# Access Compliance Report

## Public Rights-of-Way

### (Curb Ramps)

Intersection ID: 31722	Main Street: FILBERT_LN	Cross Street: WEEPING_FIG_LN	Location: NE
ADA ID: B71D7E8B2391	Ramp Type: PerpDiag	Initial Pass/Fail: Fail	Overall Compliance: No
		Severity Score: 30

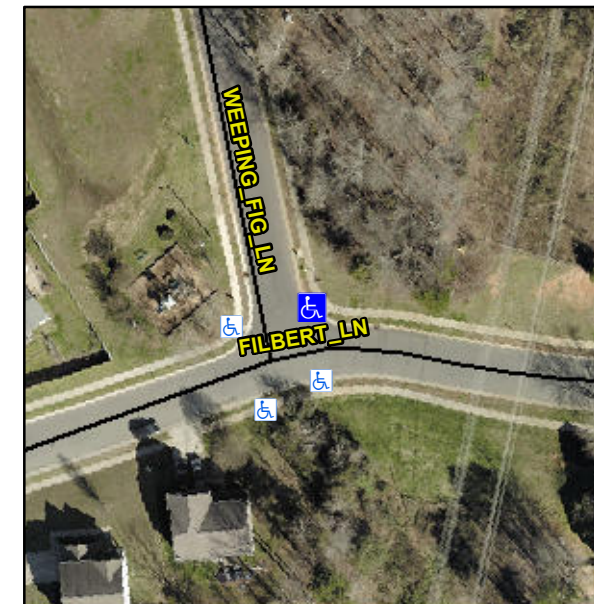
**R304.5.1, R304.5.3**

Compliance	Description	Data	Compliance	Description	Data
N/A	Ramp Length (in)	49.0	Yes	Ramp Slope (%)	6.0
No	Ramp Width (in)	35.0	No	Ramp XSlope (%)	5.3
N/A	Flare Type LT	N/A	N/A	Flare Type RT	N/A
N/A	Flare Slope LT (%)	N/A	N/A	Flare Slope RT (%)	N/A
N/A	Flare Traversable LT?	N/A	N/A	Flare Traversable RT?	N/A
N/A	Landing Length (in)	N/A	N/A	DWS Provided?	N/A
N/A	Landing Width (in)	N/A	N/A	DWS Contrast?	N/A
N/A	Landing Slope (%)	N/A	N/A	DWS Length (in)	N/A
N/A	Landing X Slope (%)	N/A	N/A	DWS Full Width?	N/A
N/A	Landing Curb? (Y/N)	N/A	N/A	DWS Offset (in)	N/A
N/A	Shared Landing?	N/A			
N/A	Gutter Ponding?	N/A	N/A	Gutter Slope (%)	N/A
N/A	Gutter Lip Ht (in)	N/A	N/A	Gutter X Slope (%)	N/A
N/A	Painted X Walk1?	No	N/A	Painted X Walk2?	No
	X Walk 1 Direction	To W		X Walk 2 Direction	To S
N/A	X Walk 1 Width (in)	N/A	N/A	X Walk 2 Width (in)	N/A
	X Walk 1 Slope (%)	0.1		X Walk 2 Slope (%)	7.9
	X Walk 1 X Slope (%)	4.5		X Walk 2 X Slope (%)	0.3

**Remove & Replace Curb Ramp With Two New Directional Ramps or Equivalent.**
